CITY OF PORTLAND, MAINE

April 3, 2017

Project Name: **502 Deering Center: 6-unit residential development plus 1 commercial space**
Project ID: #2016-290 (Subdivision & Site Plan)
Address: 502 Stevens Avenue CBL: 135-E-9
Applicant: Denis Lachman
Planner: Matthew Grooms

502 Deering Center
502 Stevens Avenue
Level III Site Plan and Subdivision Plan
2016-290
Denis Lachman, Applicant

Figure 3: 502 Stevens Avenue Street Site Plan

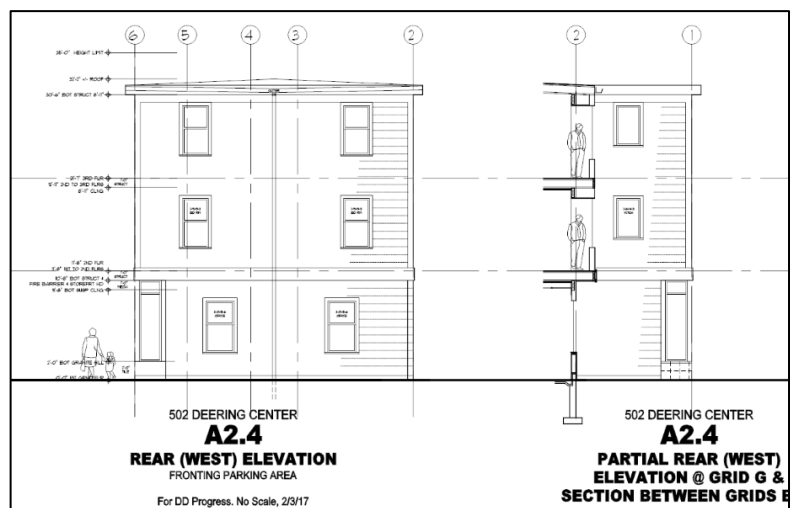
Parking for ten (10) vehicles is proposed on-site, including a space intended for a car-share vehicle, with a single two-way driveway measuring a minimum of 18' feet in width is being proposed along Stevens Avenue. Two (2) additional off-site parking spaces located at 229 Pleasant Street are presently leased. The applicant is seeking a waiver for driveway width, having asked that 18' feet be allowed whereas under the Technical Manual, 1.7.2.3., 20' feet is the minimum allowable for a multi-family residential development and 24' feet is preferred.
